Access Compliance Report

Public Rights-of-Way

Intersection ID: 7249	Main Street: HIDDEN_FOREST_DR	Cross Street: TOM_HUNTER_RD	Location: SW
ADA ID: 4115F162A082	Ramp Type: ParaDiag	Initial Pass/Fail: Fail	Overall Compliance: No
		Severity Score: 25

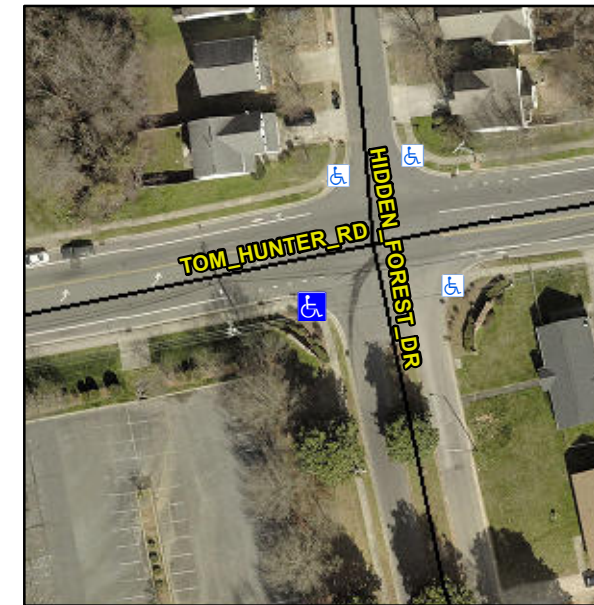
RT RP < 5%

R304.3.2, R304.5.3

Compliance	Description	Data	Compliance	Description	Data
N/A	Ramp Length LT (in)	72.0	N/A	Ramp Length RT (in)	58.5
Yes	Ramp Width LT (in)	59.0	Yes	Ramp Width RT (in)	58.5
No	Ramp Slope LT (%)	9.5	Yes	Ramp Slope RT (%)	1.1
No	Ramp XSlope LT (%)	4.8	No	Ramp XSlope RT (%)	6.5
N/A	Landing Length (in)	N/A	N/A	DWS Provided?	N/A
N/A	Landing Width (in)	N/A	N/A	DWS Contrast?	N/A
N/A	Landing Slope (%)	N/A	N/A	DWS Length (in)	N/A
N/A	Landing X Slope (%)	N/A	N/A	DWS Full Width?	N/A
N/A	Landing Curb? (Y/N)	N/A	N/A	DWS Offset (in)	N/A
N/A	Shared Landing?	N/A			
N/A	Gutter Ponding?	N/A	N/A	Gutter Slope (%)	N/A
N/A	Gutter Lip Ht (in)	N/A	N/A	Gutter X Slope (%)	N/A
N/A	Painted X Walk1?	No	N/A	Painted X Walk2?	No
	X Walk 1 Direction	To E		X Walk 2 Direction	To NE
N/A	X Walk 1 Width (in)	N/A	N/A	X Walk 2 Width (in)	N/A
	X Walk 1 Slope (%)	4.8		X Walk 2 Slope (%)	4.8
	X Walk 1 X Slope (%)	1.1		X Walk 2 X Slope (%)	1.8
N/A	Ramp inside XWalk1?	N/A	N/A	Ramp inside XWalk2?	N/A

Remove & Replace Curb Ramp With Two New Directional Ramps or Equivalent.
